SIL 23-TR-18
September, 2018
Page 1 of 2

SUBJECT: New Design Turbine Shaft Seal Ring

MODELS AFFECTED: 8000/9000 Series Product Family Transmissions

Figure 1. Former Turbine Shaft Seal Ring P/N 23016659, Butt Type End

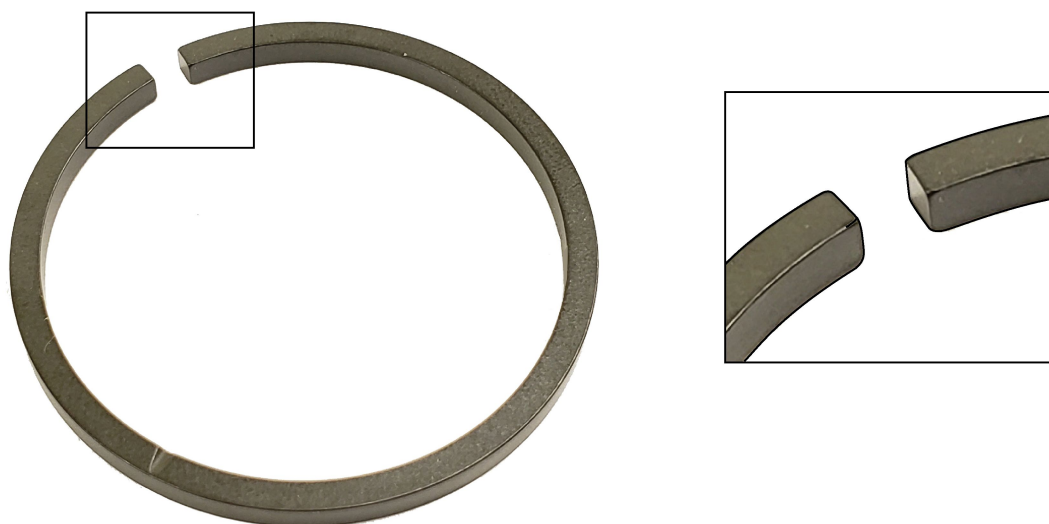
As a continuous product improvement, a new design Turbine Shaft Seal Ring P/N 29551764 has been released and implemented into production of all 8000 and 9000 Series transmissions. Current Turbine Shaft Seal Ring P/N 29551764 utilizes a hook-style design for a physical connection of the seal ring ends. This design change reduces the possibility of damage during installation and removal of the turbine.

The current Turbine Shaft Seal Ring P/N 29551764 is fully serviceable backwards. The seal ring ends must be hooked together upon installation to close the seal. The former Turbine Shaft Seal Ring P/N 23016659 has been completely canceled and the current seal ring will be used for all future production and service needs.
